**Whitehorse Planning Scheme Amendment C230whse  
Former ARRB site**

**Panel Report**

**16 March 2023**

Whitehorse Planning Scheme Amendment C230whse (the Amendment) seeks to facilitate residential development at 490-500 Burwood Highway, Vermont South by rezoning the land from Transport Zone to Residential Growth Zone Schedule 3 and applying Significant Landscape, Vegetation Protection, Design and Development, and Environmental Audit Overlays.

Figure 9 Concept Plan <sup>6</sup>

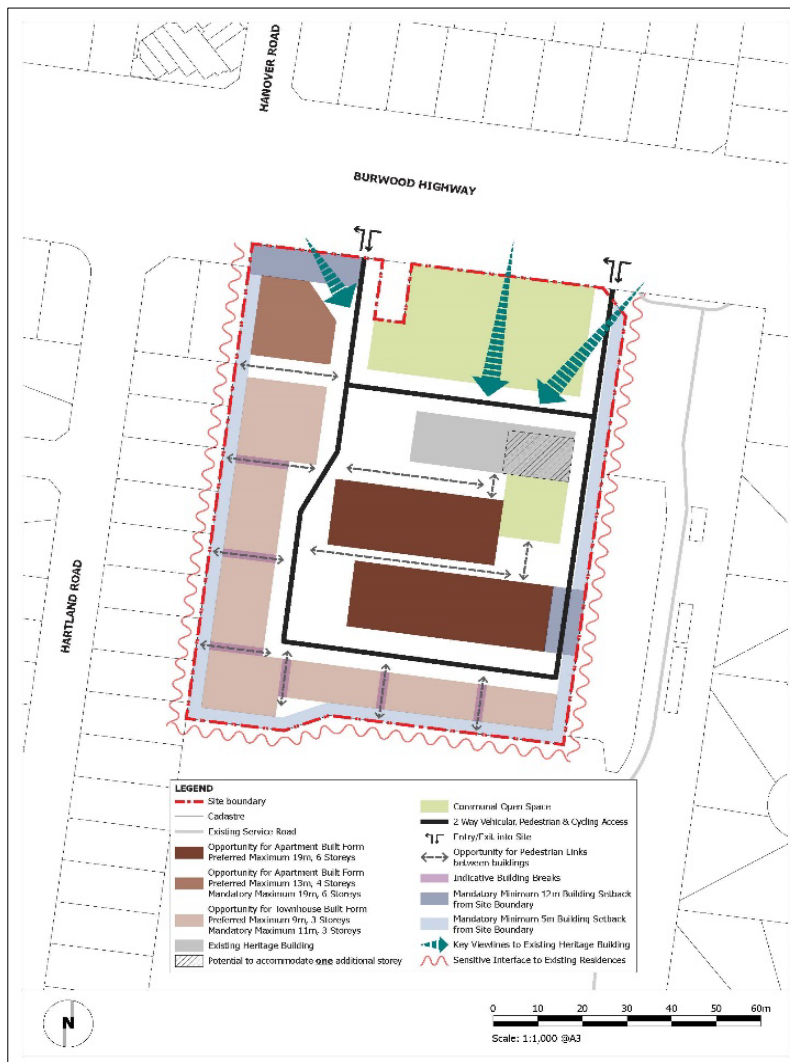
Council raised several issues about the exhibited Concept Plan (Figure 9), particularly the way in which the building heights were shown. The Panel notes the exhibited version of the Concept Plan indicated:

The first issue is the scale. It has been drawn so small that it is impossible to get a good understanding of the overall dimensions and site features, including any contours. It just can't be scaled. It seems out of context with the surrounding land uses shown, especially the widths of the roads. It does not allow a real understanding of the size of the site, its opportunities and its constraints. It is this plan that will be in the Planning Scheme, not the work undertaken by others to support this. It will be this plan that will be the subject of VCAT determinations if the permit process requires it. There should be less of the surrounding sites, and more plan and more legend.

The second issue is the level of detail in the plan. It mainly comprises indicative outlines where residential development should be focussed, along with setbacks and other indicators such as roads and paths. What it does not show are the significant stands of trees, including the three individual trees proposed for the Heritage Overlay.

The actual number of dwellings was raised to gain an understanding of how many can be accommodated. Given the Proponent advised 290 dwellings would be at the upper limit, the Panel considers that number should be included in the legend to the Concept Plan to ensure it is an accountable number.

The Panel considers the Concept Plan should be re-drawn to a reasonable scale where the different indicators can be properly shown. Due to the issues raised in other parts of this report following, the Panel ties that all together in its recommendations in Chapter 6.

- b) Retain the courtyard south of the Administration Building.
  - c) Reinstate the pedestrian link locations that were provided on the exhibited Concept Plan.

- d) Stipulate and show in metres, the mandatory setbacks from the western, southern and eastern site boundaries.
  - e) Include the location of a stormwater detention basin in the south west corner of the site, as referenced in Figure 13 of this report, with a notation that this location is indicative only.

- f) Delete the word 'vehicular' from the Legend so that it reads: *\*\*\* Mandatory setbacks exclude landscaping, fences, services, drainage infrastructure and cycling access*

- g) Delete the words *"except for plant, services and lift overruns"* and replace with *"except for architectural features"*.
3. Provide the following additional notes in the legend to the Concept Plan provided in Schedule 6 to Design and Development Overlay in Document 78, subject to:

**Figure 10 Internal road typologies (recommended)**

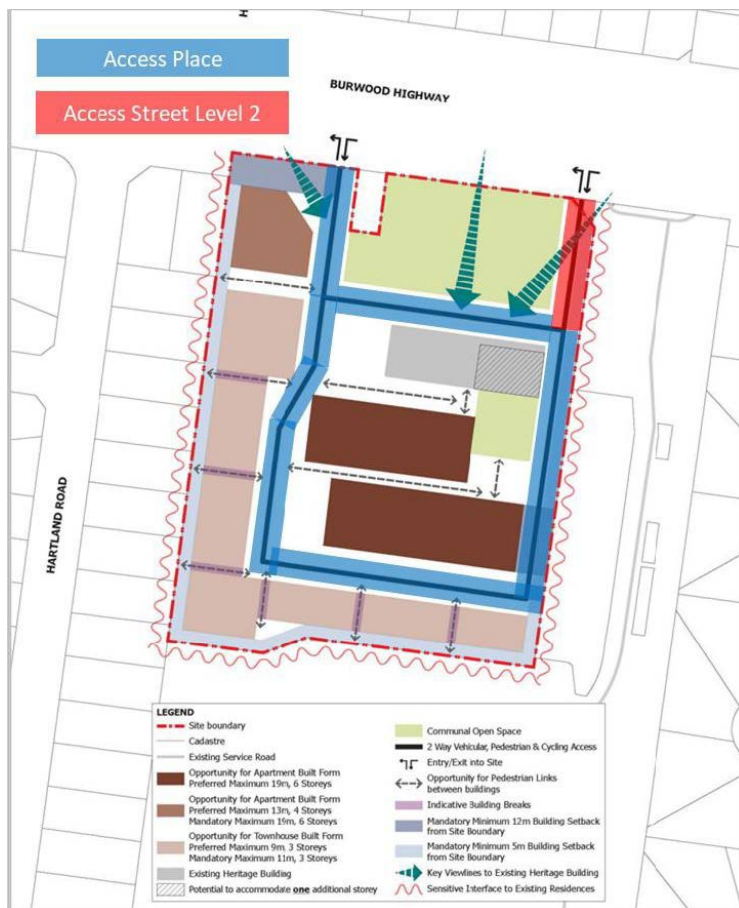
- The level of visitor parking at a rate of between 0.1 and 0.2 car spaces per dwelling is acceptable.
- The 'access place' typical cross sections adopted for the internal Council roads as shown in Figure 10 are acceptable in conjunction with mountable kerbs.
- The proposed requirements tabled by the Proponent in its amended version of DDO6 are acceptable, subject to changes provided Chapter 6 and Appendix D.

Figure 13 Concept SWMS plan showing indicative location of treatment assets <sup>21</sup>

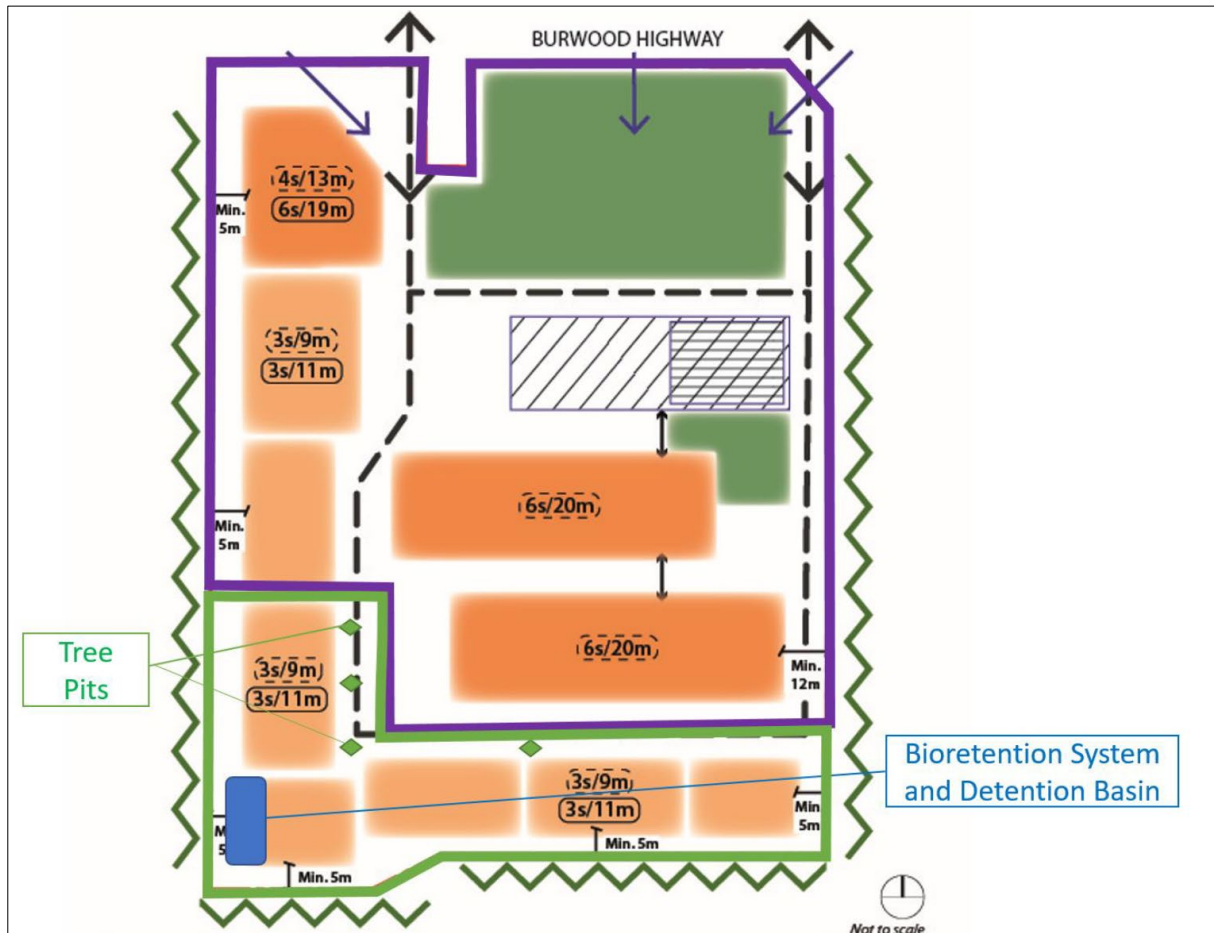
Council shares the concern that the Amendment lacks sufficient information about the nature of the future stormwater infrastructure. This was initially shown on the indicative landscape master plan in the Tract report (Fig 47). Specifically, that plan proposed stormwater retention basin and /or bio-retention basin in the south-west corner of the site.

The Panel interprets the Cardno advice to be based upon an updated concept plan, Figure 13, which includes an indicative location and layout for a stormwater retention basin.

Figure 1 - Concept Plan

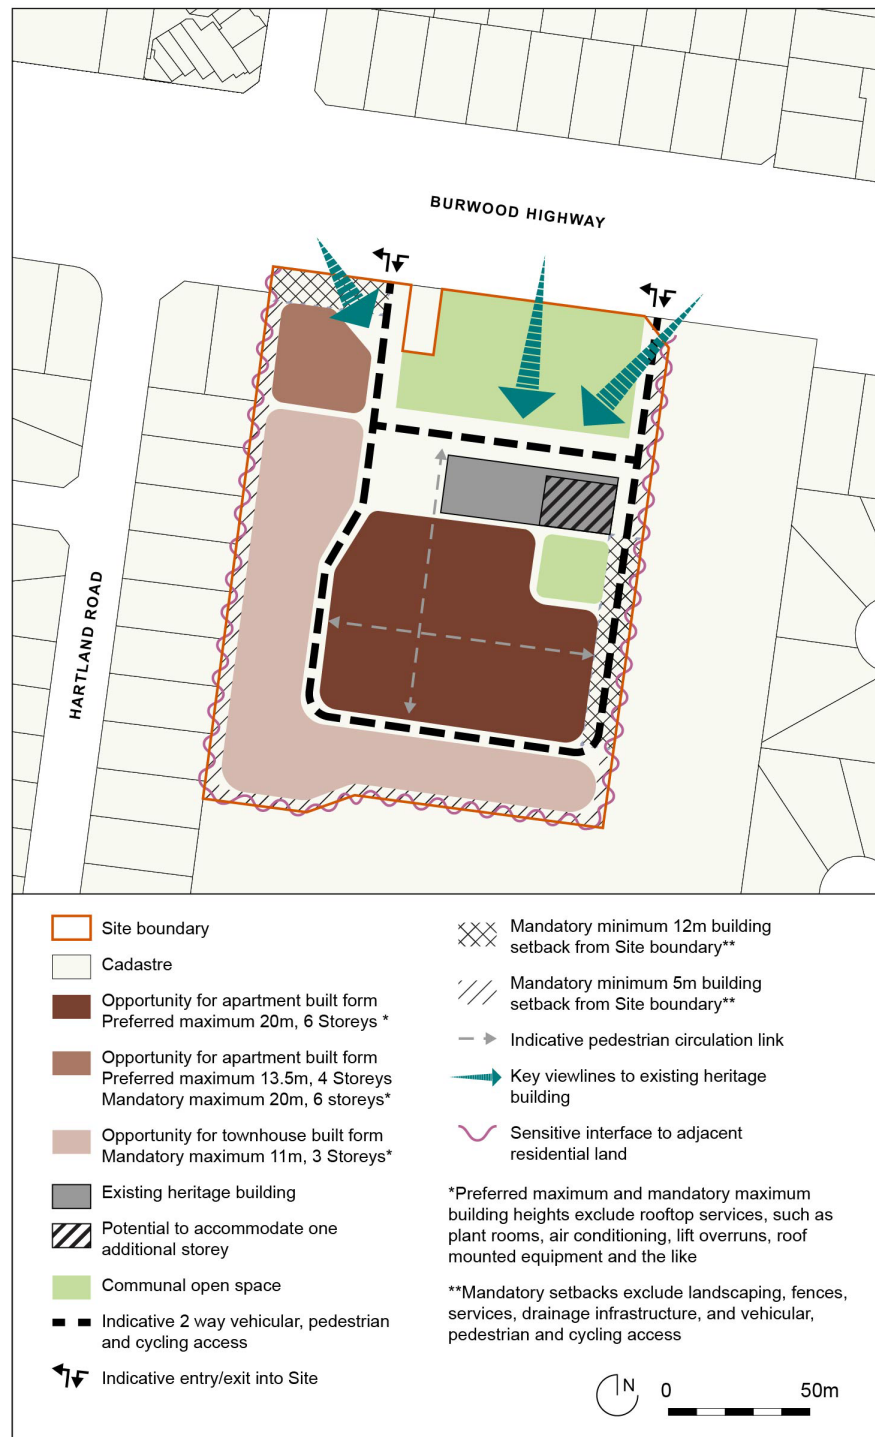
- All buildings and works should be generally in accordance with Figure 1 - Concept Plan.
- All buildings must not exceed the mandatory maximum building heights (storeys and metres), except for [architectural features](#) ~~plant, services and lift overruns~~, as indicated on the Figure 1 - Concept Plan. A planning permit cannot be granted to vary the mandatory height requirements.

- All buildings, except for landscaping, fences, services, drainage infrastructure, and vehicular, pedestrian and cycling access, must be set back a mandatory minimum 5 metres or 12 metres from land in the adjoining residential zone as shown in Figure 1 – Concept Plan to respect the existing character and amenity of established residential areas. A planning permit cannot be granted to vary this requirement.
